**Radnor Township Board of Commissioners  
Community Development Standing Committee**

**REVISED**  
**Agenda**

**Date:** September 24, 2018

**RE:** Wawa – Preliminary Plan  
Wayne Property Acquisitions Inc. – Applicant

**Table 1. Slow Release Concept – Sizing Table**

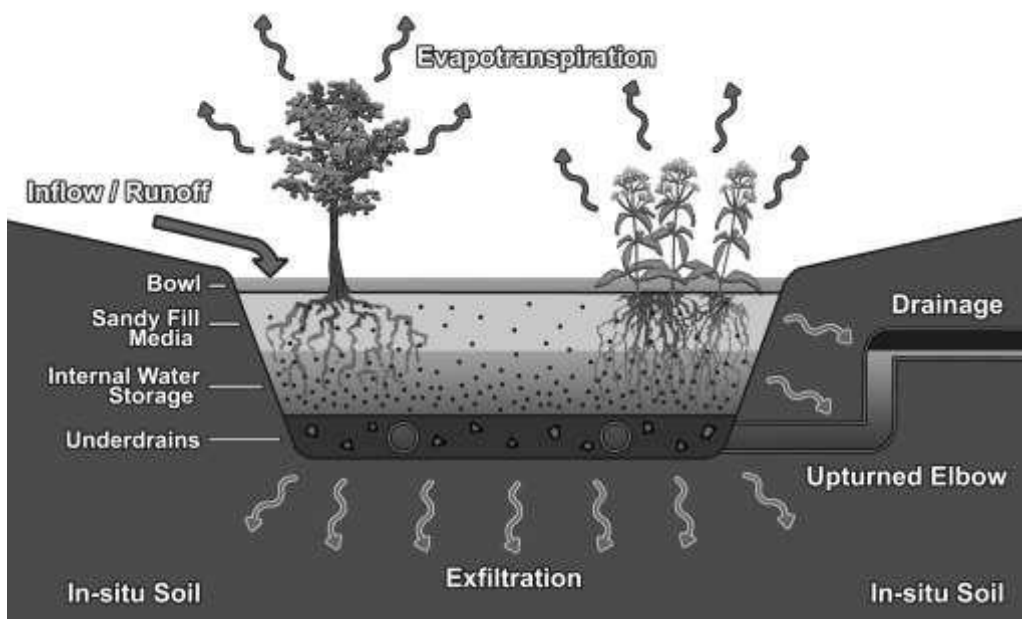
5. Appendix A includes BMP 6.4.11: Slow Release Concept (SRC) which outlines the sizing criteria in Table 1 (page 144 of the PCSM Report). Calculations must be provided to show that the SRC meets the sizing criteria.
